Officer Assessment Report

PA2302062 – 20 Wattle
Valley Road Belgrave

Officer Assessment Report
Development Approvals & Design

Figure 5 - Extract of the siting plan showing the proposed building relative to the boundary, Mount Morton Road frontage and adjoining dwellings

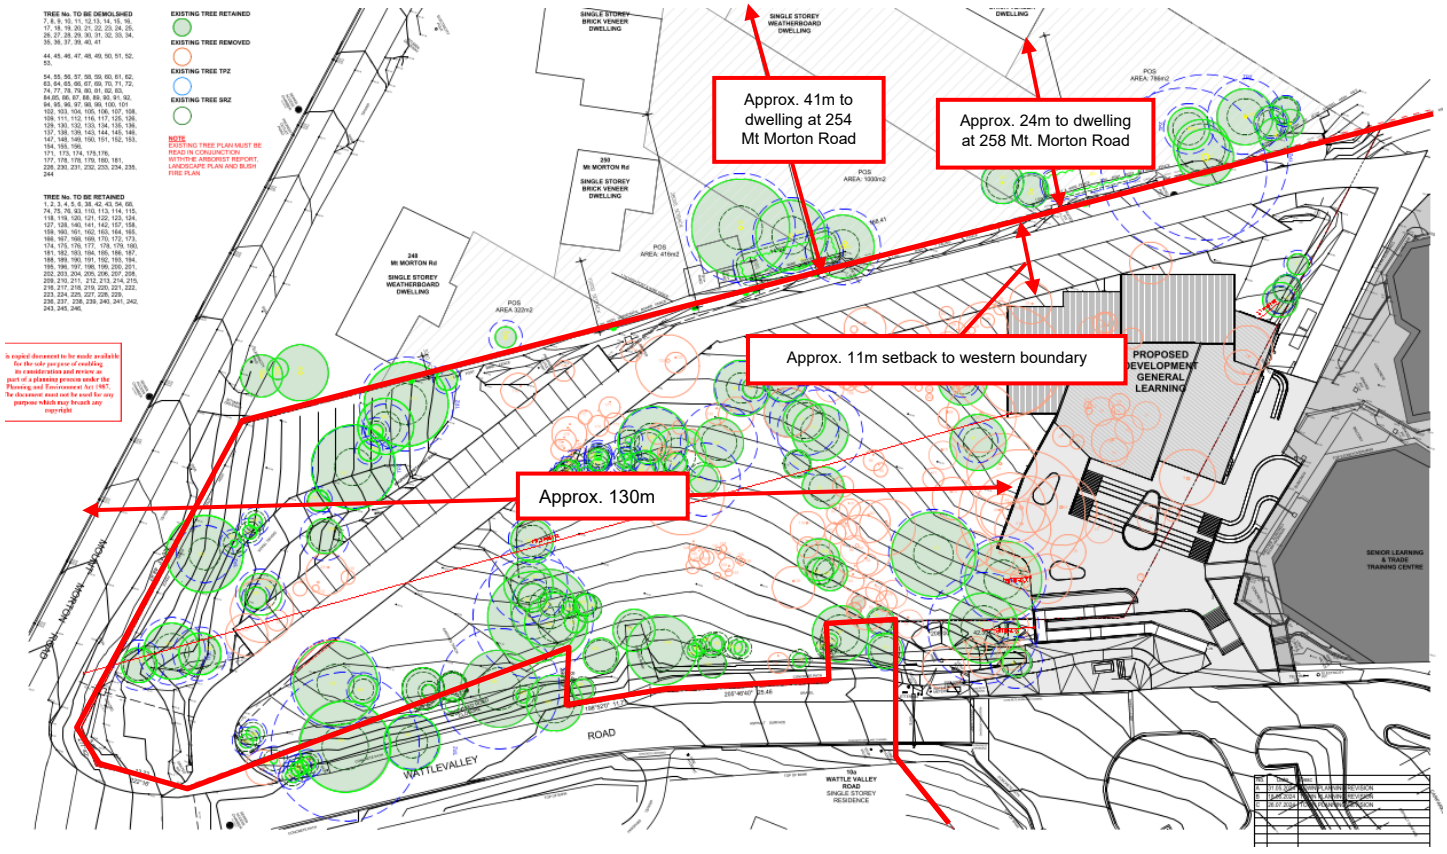
65. The building has been appropriately sited away from the property boundaries. Refer to Figure 5. This ensures that the building is subservient to retained and existing canopy trees on the subject site, maintaining the visual primacy of the existing landscape backdrop. In particular:

- The building is setback approximately 130m from Mount Morton Road, such that it will barely be visible from the streetscape and public realm.
 - From the western boundary, the new building is setback a minimum of 11m from the common (rear) boundaries with the single storey dwellings at 252, 254 and 258 Mount Morton Road. The setback is sufficient to avoid unreasonable visual impact to the secluded private open space (SPOS) of these properties. While ResCode does not technically apply to a non-residential building in the LDRZ, it is nevertheless noted that if ResCode did apply, the proposal would fully comply with the side and rear setbacks standard. Accordingly, it is considered that the proposal, while it will be visible from nearby residential properties, will not result in unreasonable visual bulk, consistent with policy at Clauses 15.01-2S and 19.02-2S of the planning scheme.

Figure 6 - An east-west section (section A-A) through the building showing its relationship with the natural ground level (outlined in red)

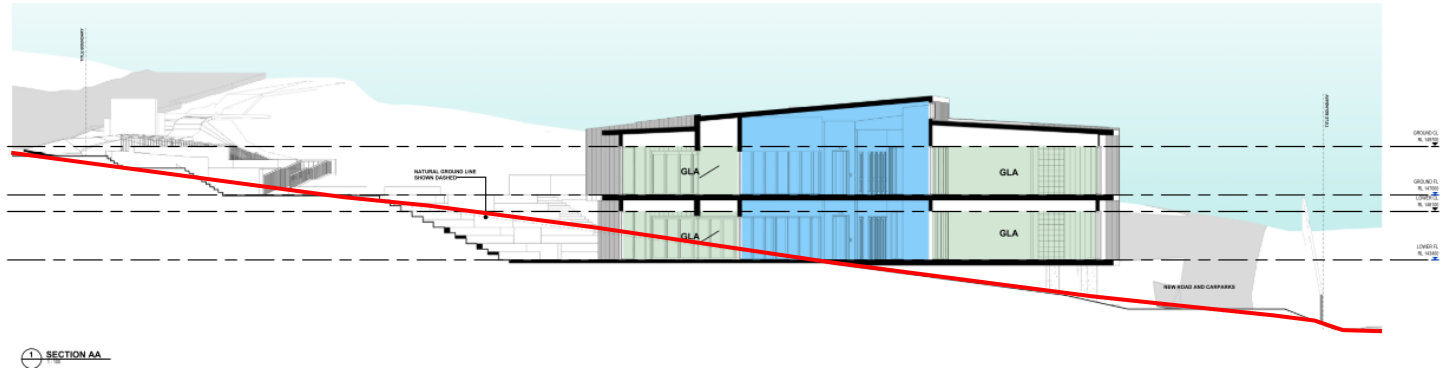
- The submitted elevations and sections show that the extent of excavation has been kept to a practical minimum and has been designed to generally complement the slope of the land. Refer to Figure 6.
- Given the positioning of the proposed building, relative to the school's broader campus, it will be barely visible when viewed from surrounding residential dwellings. This ensures that the building avoids unreasonable amenity impacts to the surrounding residential neighbourhood.

Figure 8 - Extract of the eastern elevation showing the overall 2-storey building showing its relationship with the natural ground level (outlined in red)

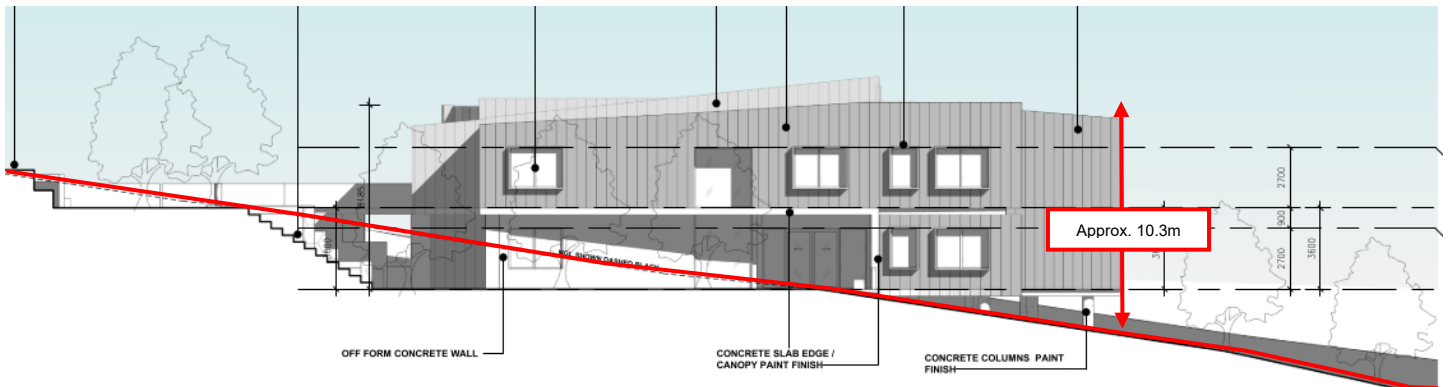
67. The new building is modern and adopts a skillion roof form through its architecture, and is modest in scale, comprising an overall height of approximately 10.3m (when measured from the eastern elevation). Refer to Figure 8.

Figure 10 - Location of the 15 areas that the burrowing crayfish were detected and the proposed translocation point for affected areas

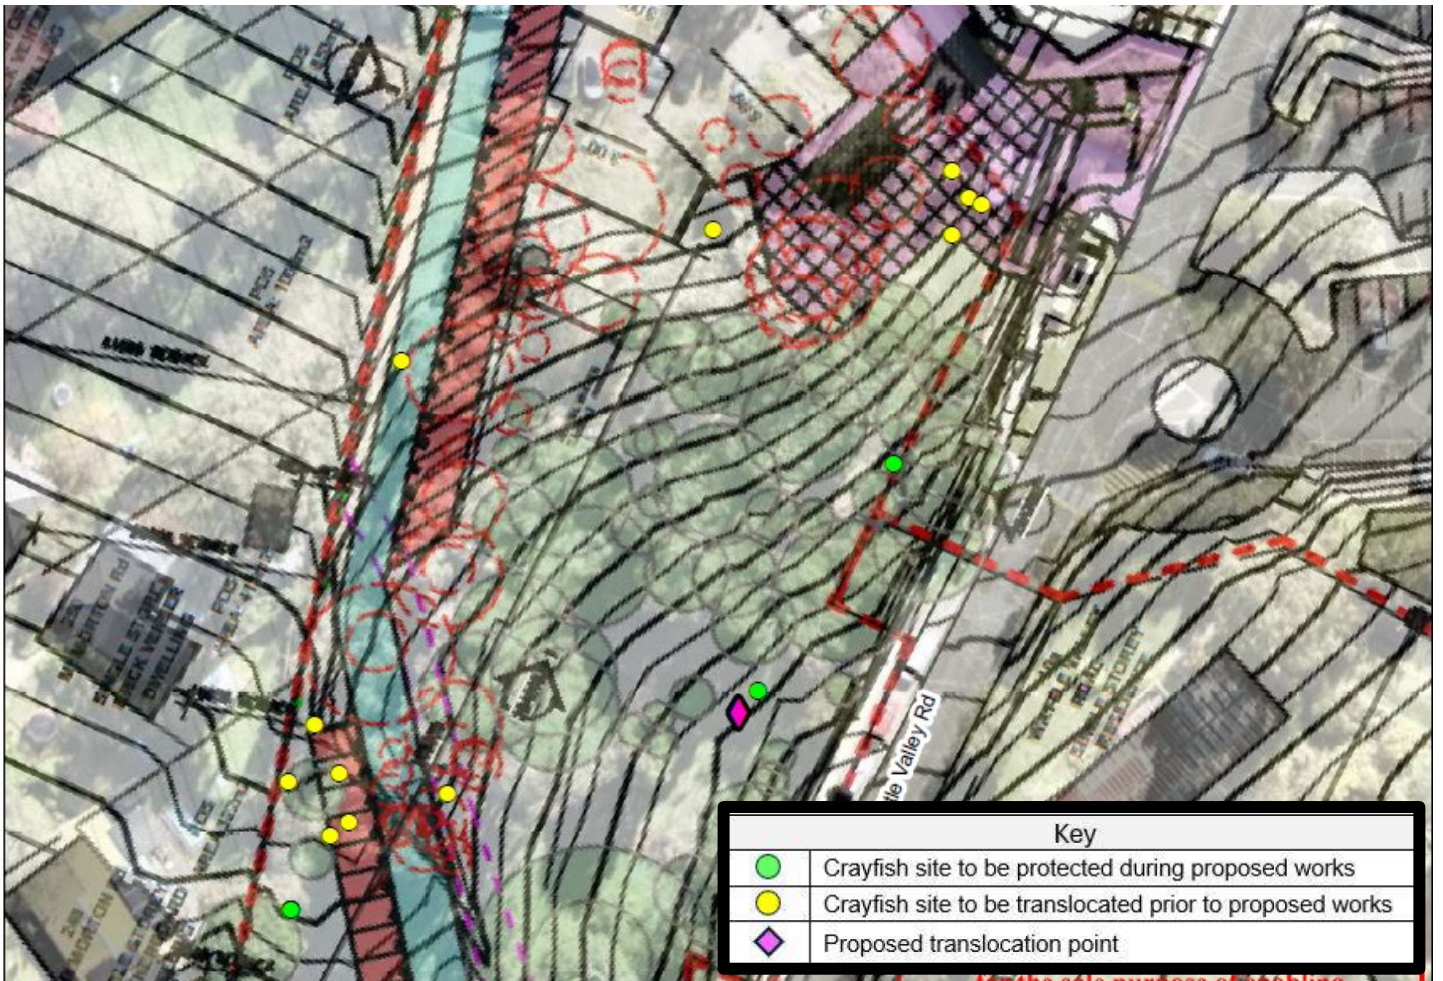
- d. Two clusters of the crayfish were evident – one along the western boundary associated with the car park and the other within the footprint of the building. It was recommended that redesign of the car park should be considered or translocation of these habitats to a central location. Refer to Figure 10.

113. There is little doubt that the burrowing crayfish is present on the site and that the proposed buildings and works will impact 12 of the 15 areas.

115. Accordingly, mitigation strategies will be confirmed by a planning permit condition to ensure that Burrowing crayfish within the construction footprint should be collected and translocated prior to the commencement of construction, and crayfish habitat outside of the footprint be fenced off and protected during construction.

Figure 11 - Extract of the new car parking layout and vehicle access

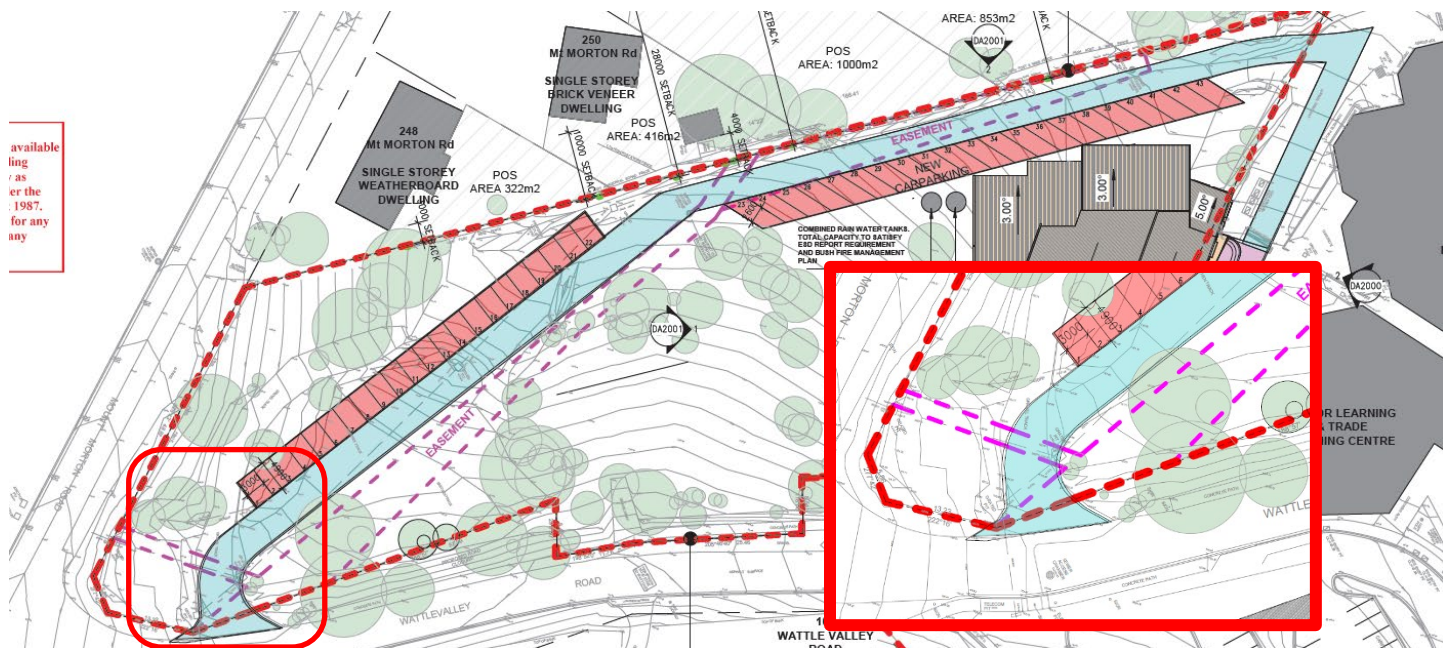
126. The new car parking layout has also been assessed:
- The car parking spaces that are perpendicular with its accessway are 3m wide and 4.9m deep. This complies with the requirements of the planning scheme. Its respective accessway is approximately 5.7m wide, exceeding the minimum planning scheme requirement of 5.2m.

- The car parking spaces that are angled 45 degree to the accessway are 2.6m wide, and 7m deep. This complies with the requirements of the planning scheme. Its respective access is 4.3m wide, exceeding the minimum planning requirement of 3.5m.

- The council and CFA identify that turn-around provisions have not been adequately demonstrated / shown on the plans in relation to firefighting capabilities. The applicant has noted that the proposed access will link with an existing loop road around the campus for CFA access and firefighting. Accordingly, it will be a condition of permit requiring that the plans are updated to clearly show this turn-around provision (or similar).
